CITY PLAN COMMISSION STAFF REPORT

Project Name
MC 106 Data Center

Request
CD-CPC-2023-00016
Development Plan

Report Date: April 27, 2023

SITE PLAN

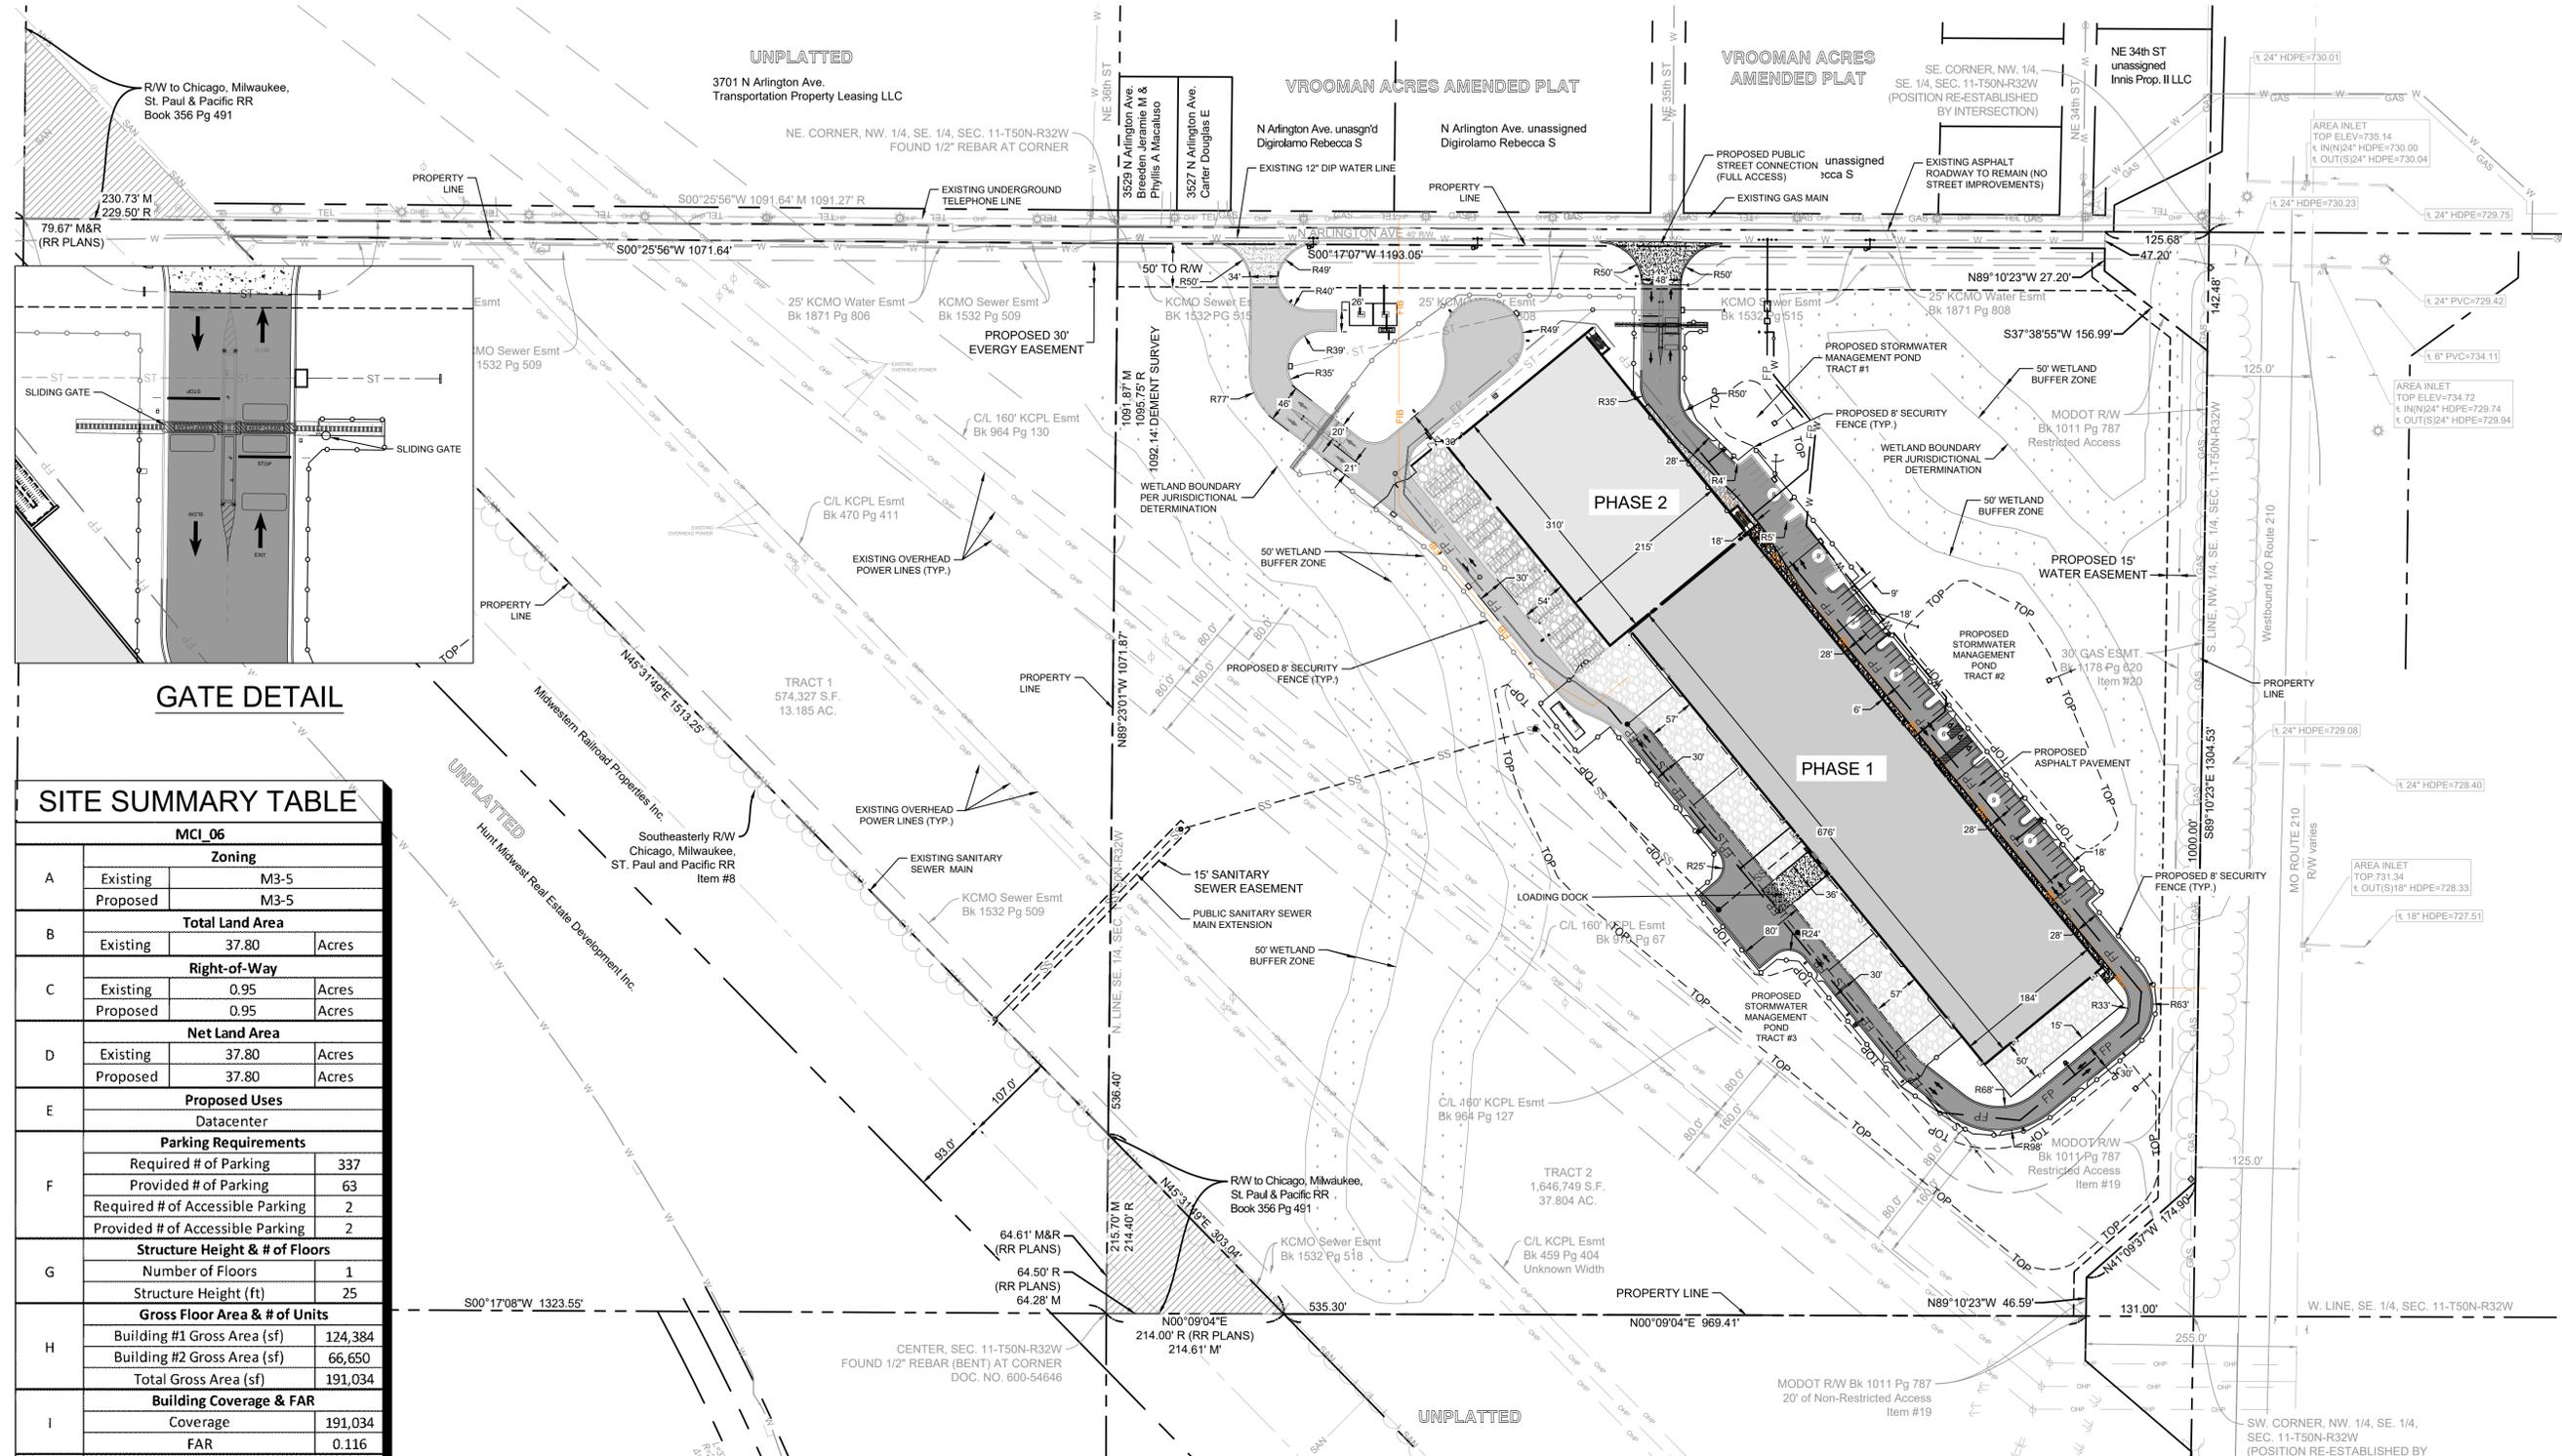
5. Relocate the second entrance to align with NE 36th Street to avoid impacting the three existing detached residential homes at the southeast corner of NE 36th Street and N. Arlington Avenue. Revise Plans and Resubmit (4/27/2023)

6. Show reciprocal cross access easement on the second drive to be able to serve the parcel to the north of the subject parcel. Revise Plans and Resubmit (4/27/2023)

9. Show internal sidewalks connection extended to N. Arlington Avenue. Revise Plans and Resubmit (4/27/2023)
 10. Correct Site Summary Table to show the building height of phase 2. Correctly show the building height and the number of floors. Revise Plans and Resubmit (4/27/2023)

11. Update parking calculations to cover shift changes also. Revise Plans and Resubmit (4/27/2023)
 12. Show all building and parking setbacks and dimensions on site plan. Revise Plans and Resubmit (4/27/2023)

13. Provide alternate parking compliance request for vehicles and bicycle parking on the face of the plan. This should include required number and the percentage of deviation and why. Revise Plans and Resubmit (4/27/2023)

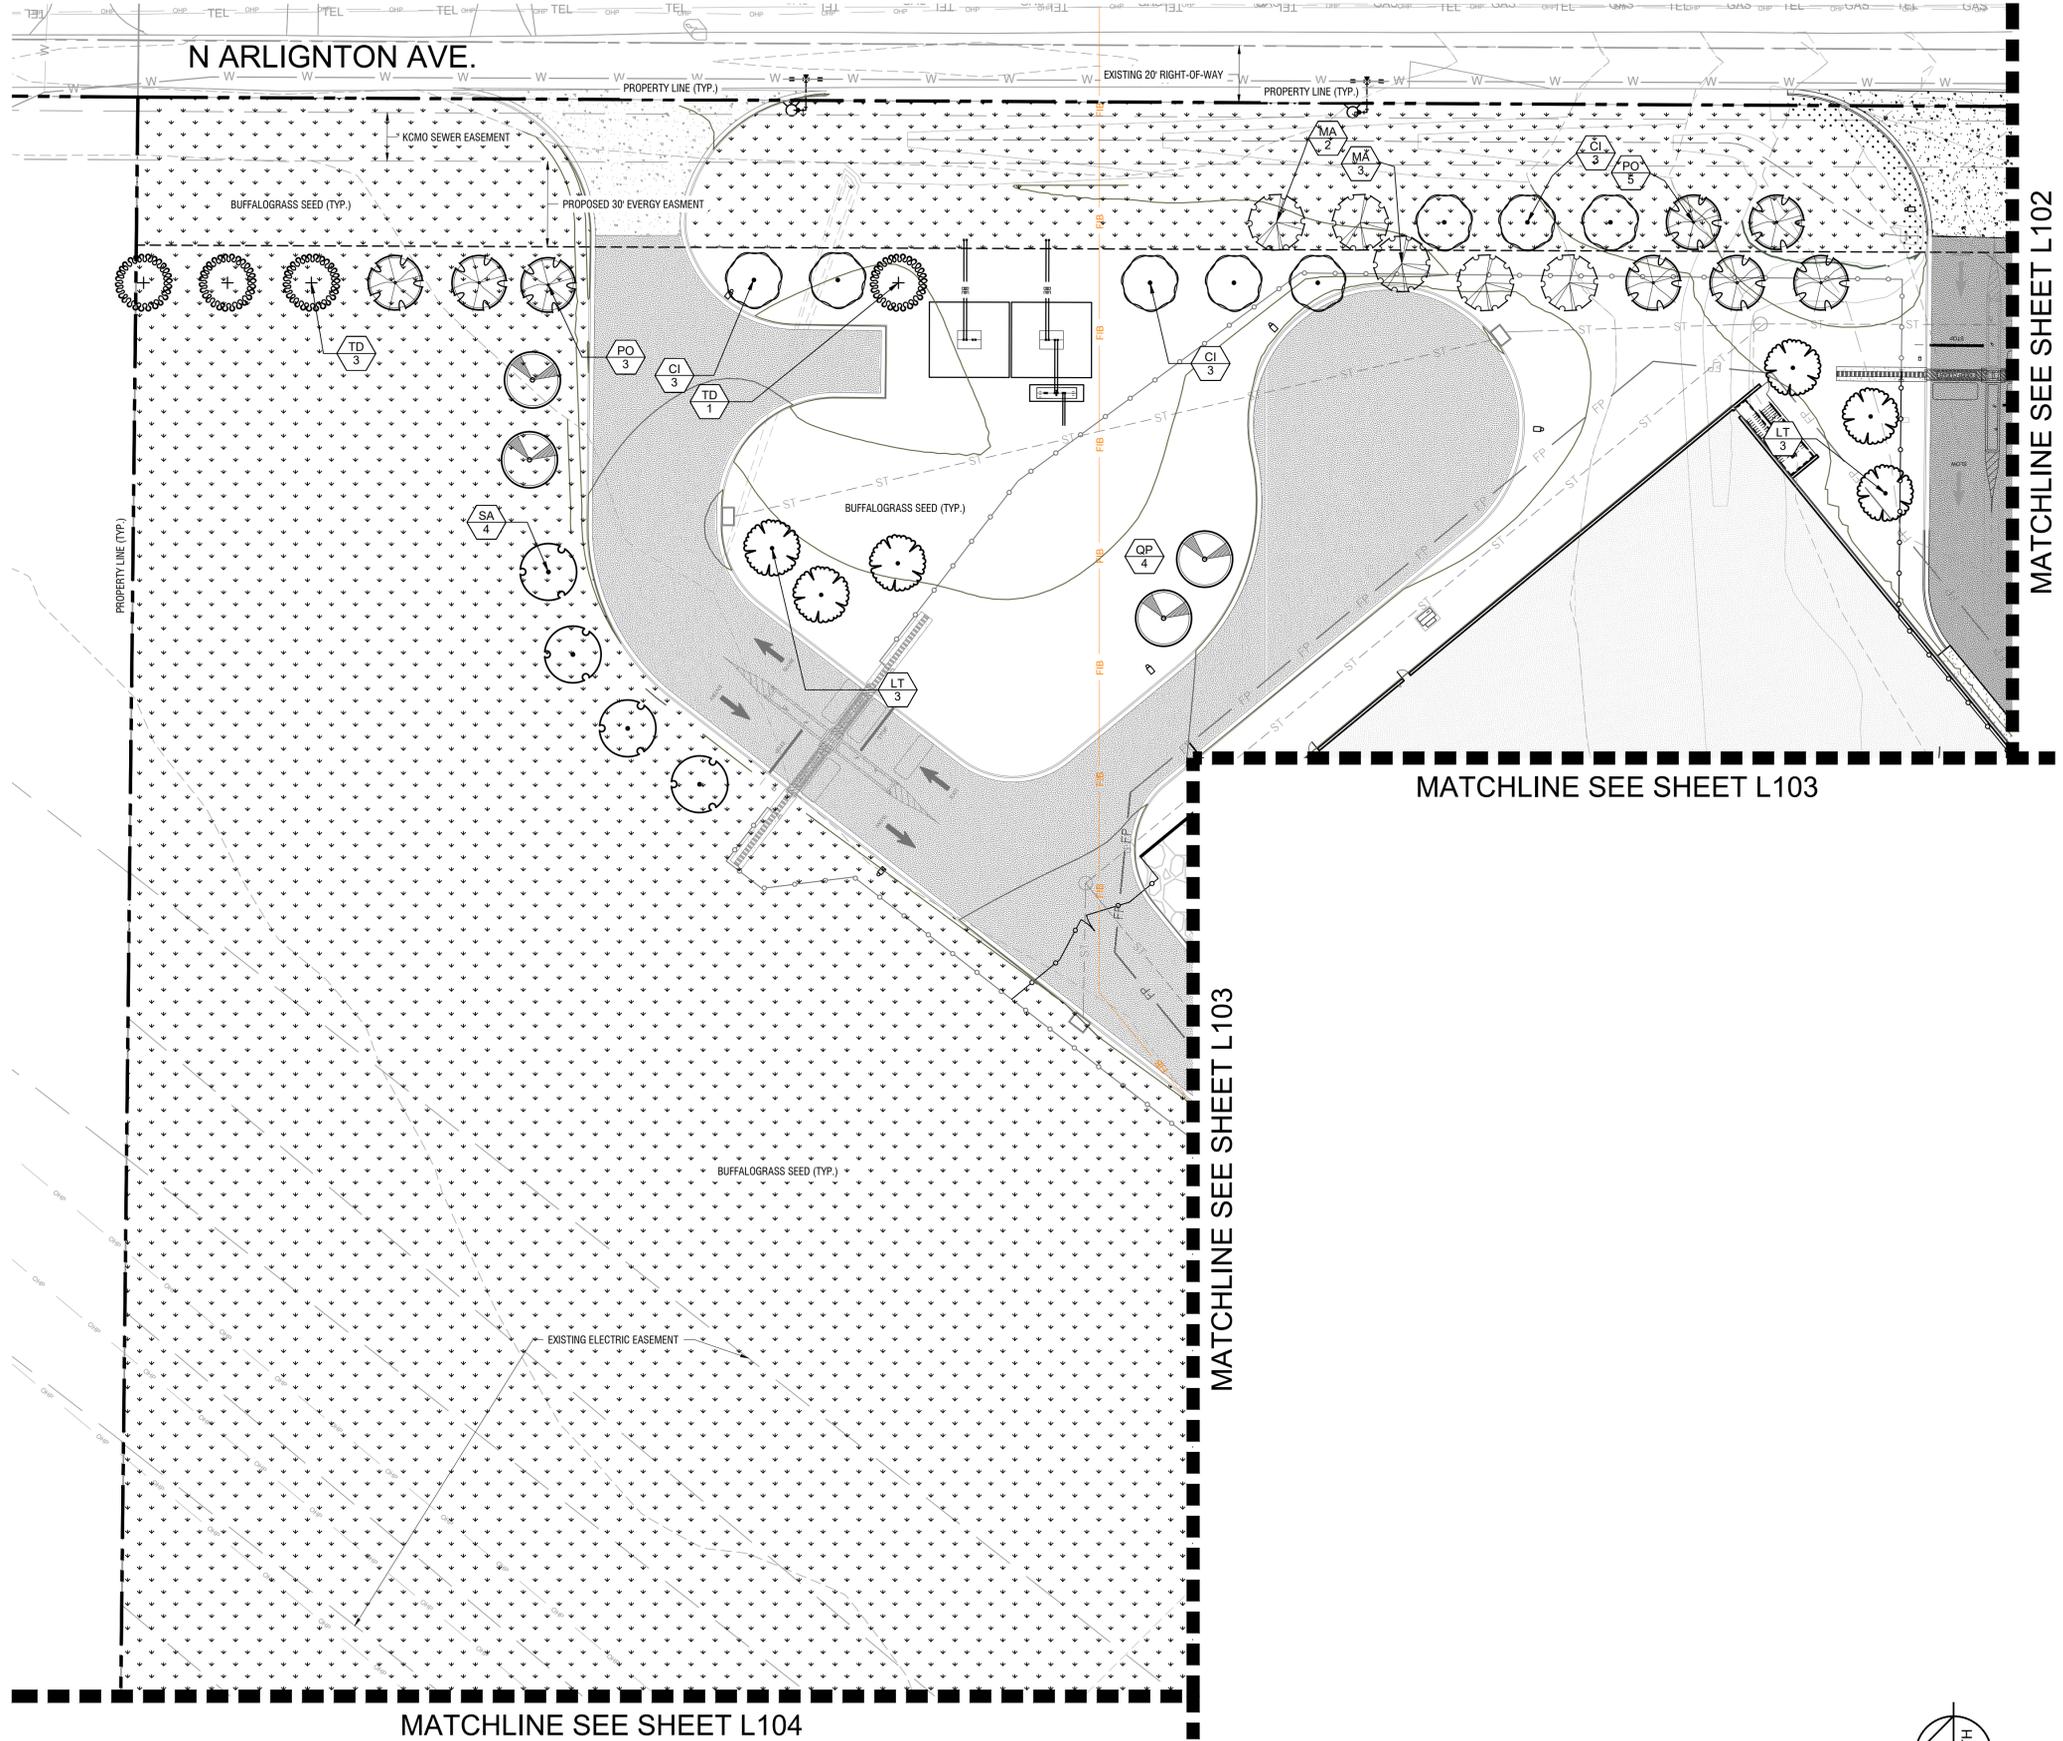
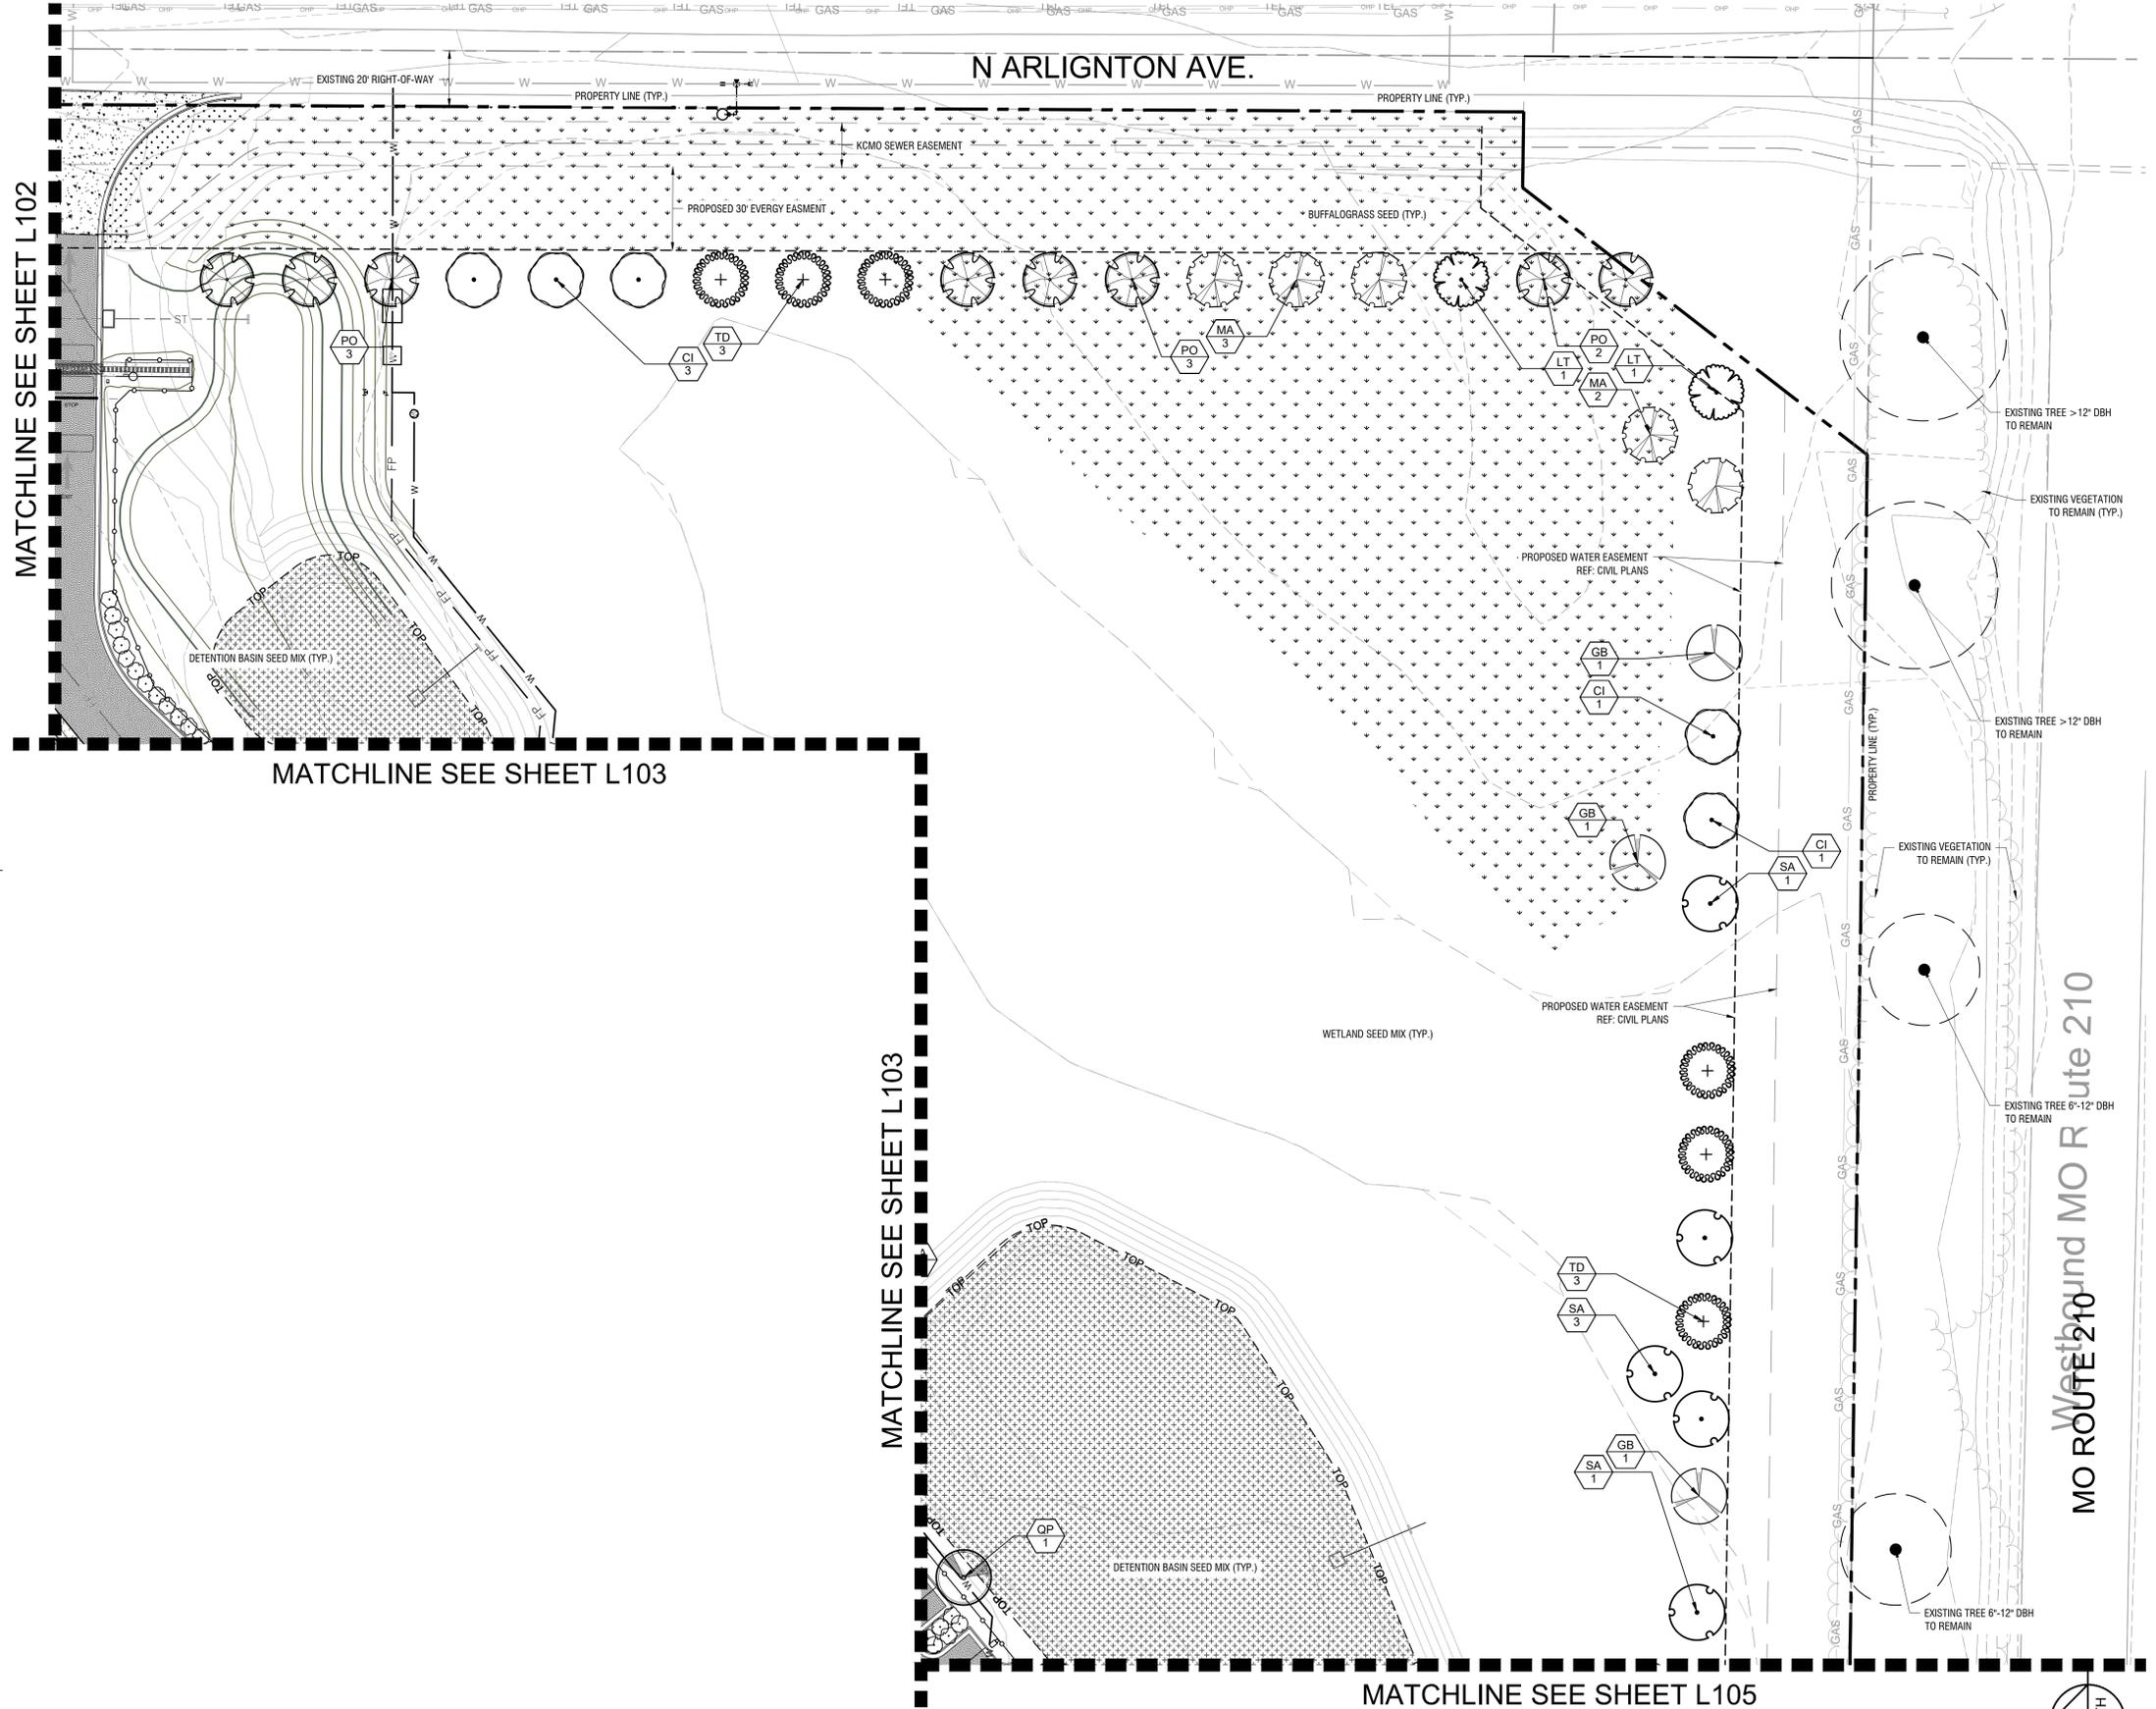
1. Submit evidence of approval by MoDOT prior to ordinance request.
 2. Revise the landscaping plan to show a berm and continuous row of evergreen shrubs along N. Arlington Avenue to screen the existing residences on the east side of N. Arlington Avenue per staff approval prior to ordinance request (4/17/2023)
